**PERMISSIBLE VARIATIONS FOR HOUSEHOLD SHELTER (HS)/STOREY SHELTER (SS) TECHNICAL REQUIREMENTS**

**Permissible Variations For Technical Requirements For Household Shelters**

Permissible Variations For Technical Requirements For Storey Shelters

**FIGURE 1: USAGE OF TRELLIS (RC/STEEL HOLLOW SECTIONS) FOR 3 HS WALLS**

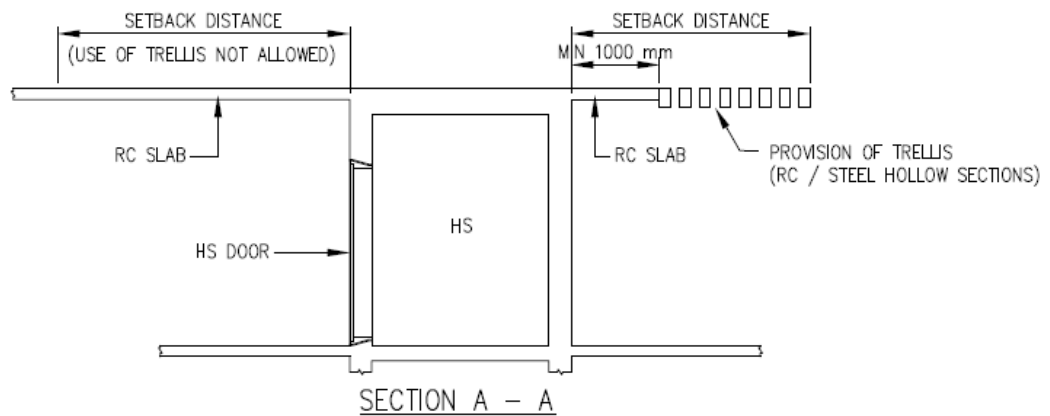
S/No	Clause stipulated in Technical Requirements For Household Shelters 2008	Design Issue	Conditions for Acceptance
1	<p>Clause 2.3.3 The setback distances of HS wall shall comply with Table 2.3.3.</p> <p>Clause 2.3.4 The setback distances of HS wall shall comply with Table 2.3.4(a) or Table 2.3.4(b).</p>	<p>Provision of RC ceiling slab does not meet the minimum setback distance requirements.</p>	<p>Trellis constructed of RC or steel hollow sections may be used to make up for the shortfall in setback distance for three HS walls (where the HS door is not located). However, a minimum of 1000mm RC ceiling slab from the HS wall shall be provided (See <b>Figure 1</b>). A perpendicular or parallel trellis arrangement, or a combination of both, with respect to the HS wall concerned, shall comply with the geometrical configuration (See <b>Figure 1</b>).</p> <p>Provision of trellis to make up for shortfall in setback distance of HS wall with door is not allowed, i.e. RC ceiling slab with required minimum setback distance is to be provided.</p>

W1 = MIN 125 mm  
S1 = MAX 100 mm  
D1 = MIN 125 mm

W2 = MIN 125 mm  
S2 = MIN 62.5 mm  
D2 = AT LEAST 2 TIMES OF S2

THICKNESS OF STEEL HOLLOW SECTIONS SHALL BE AT LEAST 6 mm

FIGURE 2: HEIGHT OF VENTILATION SLEEVES BETWEEN 1900 mm TO 3600 mm

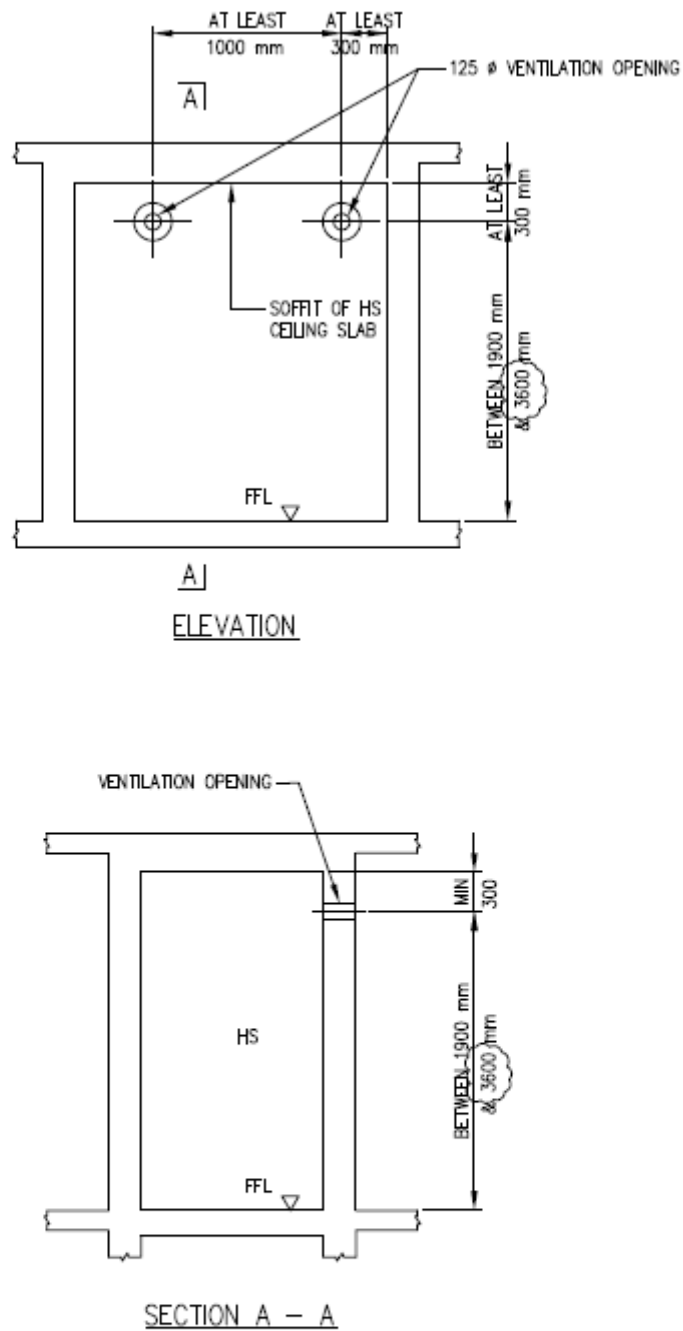
2	<p>Clause 4.2 The height of each opening, measured from the centre of the opening to internal finished floor level (FFL) of the HS shall be between 1900mm to 2600mm, as shown in Figure 4.2(b).</p>	<p>The installation of the ventilation sleeve opening(s) at height above 2600mm.</p>	<p>The location of ventilation sleeve(s) at height between 1900mm to 3600mm, measured from centre of the ventilation sleeve opening to internal FFL of the HS, is permitted (See <b>Figure 2</b>). If the location of the ventilation sleeve is to be in the false ceiling, access panel(s) of minimum size of 600mm x 600mm shall be provided, positioned directly below the ventilation sleeve and the ventilation sleeve shall be accessible with ladder.</p>

**FIGURE 3: WIDTH OF NIB IN MV SHAFT**

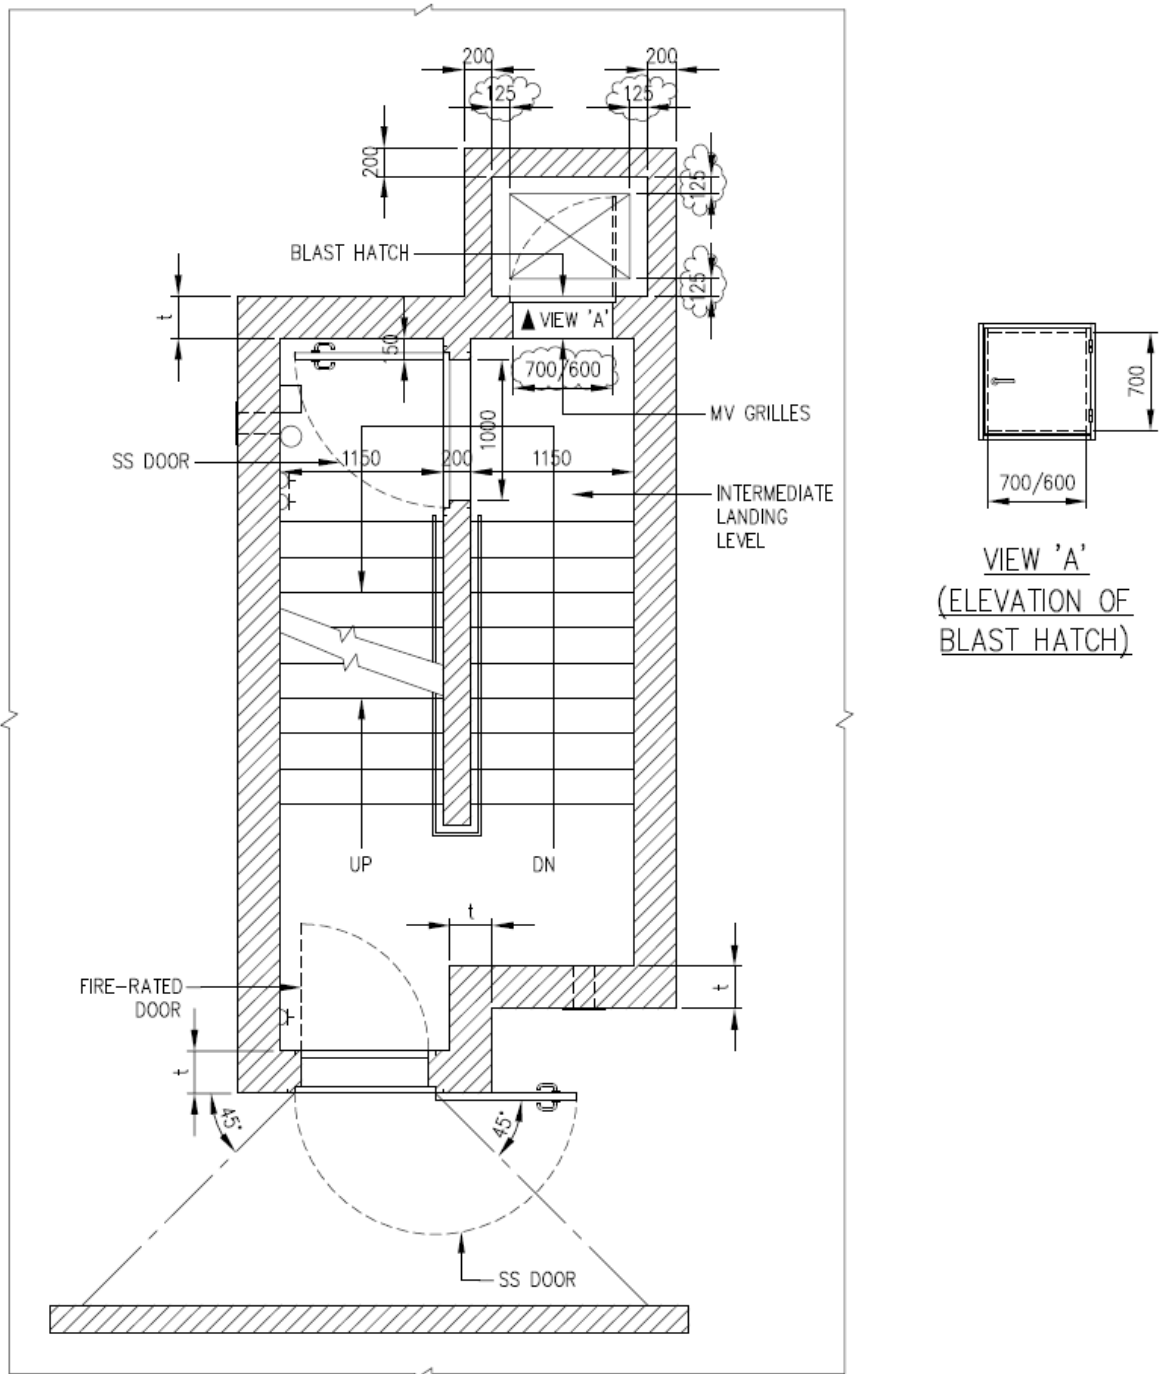
S/No	Clause stipulated in Technical Requirements For Storey Shelters 2006	Design Issue	Conditions for Acceptance
1	Clause 2.11.6 There shall be 200mm width reinforced concrete or steel nib provided around the MV shaft for inspection and maintenance of the blast hatch for layouts shown in Figure 2.11.1(b-1).	To fulfil the pressurization requirements for exit staircases, as specified in the Fire Code.	a. The reinforced concrete or steel nib around the MV shaft shall be of width of at least 125mm (See <b>Figure 3</b> ). b. The height of the blast hatch opening shall be 700mm, whereas its width shall be between 600mm-700mm.

WALL THICKNESS,  $t$  (TO FOLLOW TABLE 2.4 OF THE DESIGN GUIDELINES)
